SUMMARY OF PROPOSED CHANGES TO DCPRS CERTIFICATION STANDARD

DESCRIPTION OF THE PROPOSED CHANGES IN NUMERICAL ORDER

3.1 DCPRS Data Format. The figure below defines the required message format.

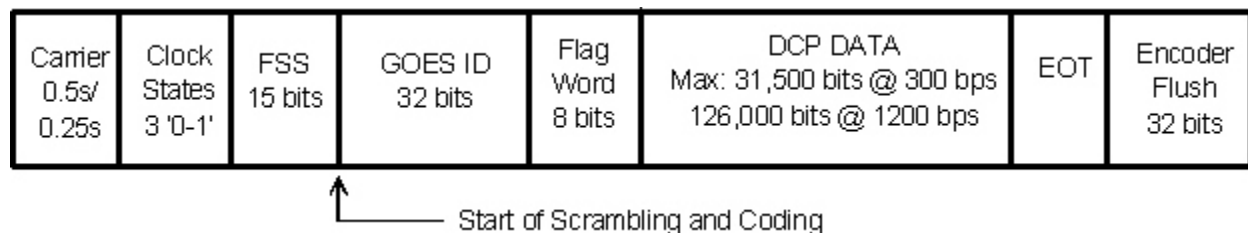
NOTE: The changes shown below also include the results due to other changed detailed in following parts of this document.

3.1 DCPRS Data Format.

The format for all messages shall meet the following format requirements.

Clock: 3 symbol periods, first 0 degrees, then 180 degrees, then 0 degrees.

The following 15 bit pattern shall be sent at the appropriate symbol rate with "0" representing 0 degrees and "1" representing 180 degrees:
 (MSB) 0000010111001110 (LSB) The left most bit is transmitted first.

After the FSS is transmitted the GOES ID and all data shall be scrambled, and trellis encoded, as defined below.
